VNI-West Consultation Report - Options Assessment

This document has been prepared by Simon Bartlett and Bruce Mountain and is submitted to the AEMO Victorian Planner (AVP) and TransGrid, pursuant to their invitation for submissions on the VNI West Consultation Report Options Assessment (“Consultation Report”).

Figure 7 Breakdown of cumulative gross benefits for Option 5 under the Step Change scenario

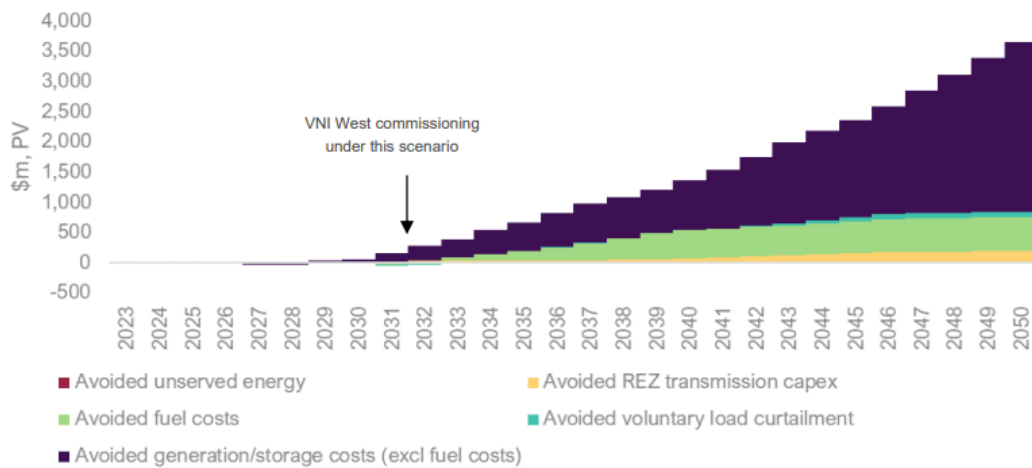
For WRL-VNI, Figure 7 of the Consultation Report shown below for the Step Change scenario, the claimed cumulative gross benefits for Option 5, comprises:

- a)* avoided generation/storage costs (by far the largest benefit – 75% of the total) that appears to grow until 2037, when they cease growing, but start again growing exponentially during the 2040's reaching \$2,700m cumulative PV in 2050.
- b)* Fuel cost savings grow to \$500m cumulative PV by 2040, when they cease growing during the 2040's. This means there are virtually no fuel savings, due to Option 5 beyond 2040, and also out to 2080.
- c)* Avoided REZ transmission costs are immaterial until 2039, but grow during the 2040's – very strange.
- d)* Avoided involuntary load curtailment are also immaterial until the 2040's – again strange.

The last three categories combined, reach around \$400m PV by 2040, but somehow grow to \$800m by 2050.

5.1.2 Understated WRL Uprate cost

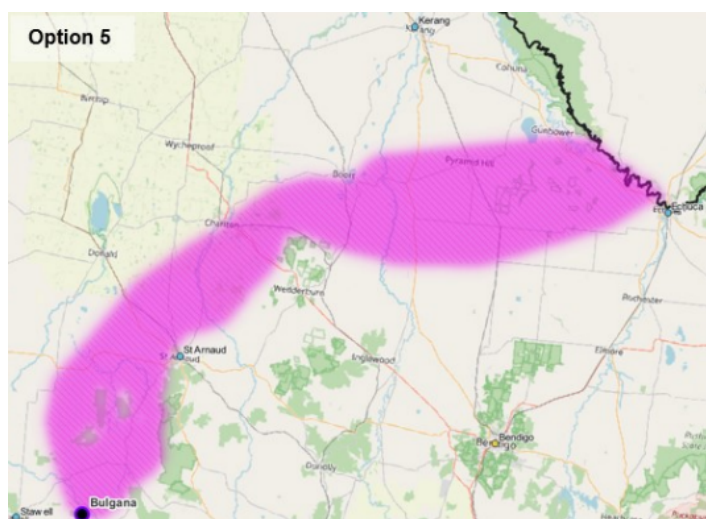
Appendix A.2 of the Consultation Report “Cost estimating methodology for the VIC components” confirms that there is no risk allowance in the VIC 500kV transmission line cost estimates which are based solely on TCD cost estimates. The only allowance for a contingency above the TCD cost estimates is in estimating the WRL uprate costs, however in that case the contingency has been incorrectly applied as shown below. The incremental costs attributed to VNI West for uprating WRL has been calculated as follows:

“To estimate these costs, the per kilometre cost for the current 220 kV line was subtracted from the current market cost for the 500 kV line, while still accounting for known risks by means of an added 30% contingency. The higher voltage line will also require a wider easement[.]”
Reference from Consultation Report

The correct calculation would be to first increase the TCD cost estimate for the 500kV line by 40% (to allow for adjustments and overheads as well as known and unknown risks) subtract AusNet’s costs for the 220kV line no longer required (noting AusNet would have included appropriate contingencies in their contract sum), add in the cost of the additional Waubra 220 kV works and AusNet’s required profits for the uprating and any wasted expenditure on the 220kV line works. The approach used has omitted the 40% contingency required for TCD cost estimates for a 500kV line (i.e., 40% of \$2.91m/km for 104kms (i.e., \$121m), only added a 30% contingency on the difference between AusNet’s price for the 220kV line and the TCD price for 500kV (i.e., \$32m), has omitted the cost of the Waubra works for Option 5 (\$20m?) and it’s unclear how or where AusNet’s wasted expenditure to date and their required profit margin is included. The \$315m allowed in Option 5 appears to be understated by at least \$109m and it is impossible to check how much has been included for the last two items due to the lack of transparency and the use of incremental costs instead of the full cost as required in the RIT-T instrument.

Figure 55 Areas of interest for indicative alignments

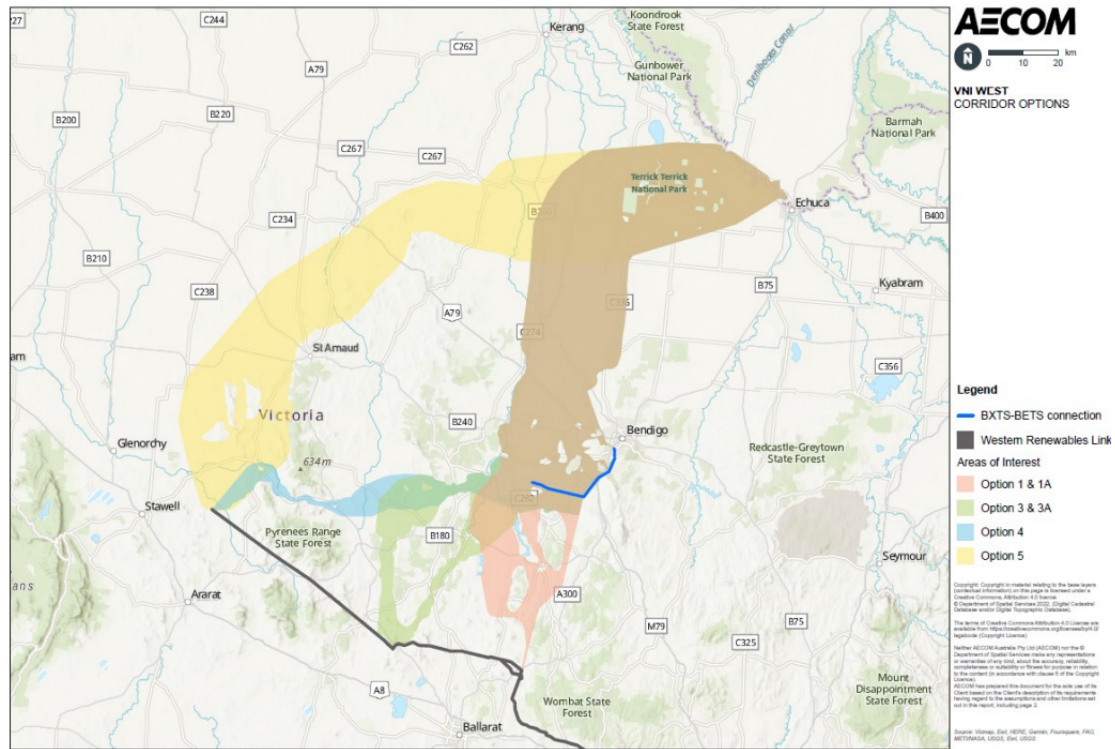
Figure 55 from the Consultation Report, repeated below shows clearly that option 5 is much longer than option 1. Using the scale on this figure, the total length of the 500kv lines between Ballarat and the border crossing point downstream of Echuca is ~335km via WRL and option 5 compared with a ~189km for option 1. The additional 146km would cost \$m596 at \$m4.08/km. This is the increased cost of the 500kV transmission lines from moving the WRL/VNI West connection point from Ballarat to Bulgana. The blue line in figure 55 appears to be a new 35km long 220kV transmission line between

the new Bendigo 500kV/220/kV substation (BXTS) and the existing Bendigo 220kV substation (BETS).

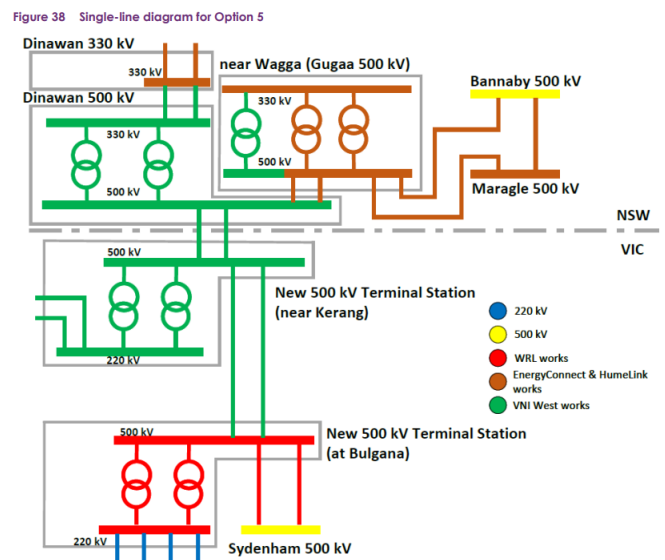
Table 5 of the Consultation Report claims that there are no new substations required in NSW and only one in VIC yet the estimated cost of VIC substations in Option 5 is \$418m compared with \$354m in NSW. In truth, a new 500kV substation is required at Dinawan and two new substations (a 500kV substation and a 220kV substation are required at Kerang, which simplistically, would result in the VIC substation costs being twice the NSW substation cost (i.e., \$708m being twice \$354m compared with the \$418m in Table 5. A closer look below of the required scope of substation works for Option 5 confirms that the VIC works are much greater than the small cost difference implies:

- a. Gugga and Bulgana substations have similar scope of works as both require two additional 500kV switching bays and reactors. Gugga also requires a transformer. Bulgana appears to require four outgoing 220kV feeders shown in blue not required at Gugga or North Ballarat, but it is unclear what their purpose is in the Consultation Report. Bulgana substation may also be required to provide the additional land and various services to the series compensation facilities.

- b. Dinawan requires the establishment of the brown fields 500kV substation with two transformers adjacent to the PEC 330kV substation.
- c. Kerang requires green-field 500kV and 220kV substations requiring extensive excavation and civil engineering works with two transformers, with an access road, auxiliary power supplies, water supply, emergency diesel generators, duplicated telecommunications facilities and security fencing none of which are required at Gugga or Dinawan. It also must provide connections and services to the series compensation at Kerang and the 220kV power flow controllers. These substation servicing costs will be in addition to the costs of the power flow controllers and series compensation and their additional substation costs in Table 5. It is estimated that these additional works would easily add more than \$25m to \$50m to the equivalent brown-field substation costs in NSW.

- d. There are also the additional costs of redesign, scope change, relocation and plant storage costs to vary the existing contract with AusNet Services to enable relocation of the North Ballarat substation to Waubra or Bulgana. Based on the difference between the substation costs between options 1 and 3, these variation costs appear to be around \$63m. This alone accounts for the \$64m difference between the NSW and VIC substation components, without allowing for the large scope difference at Kerang described above.
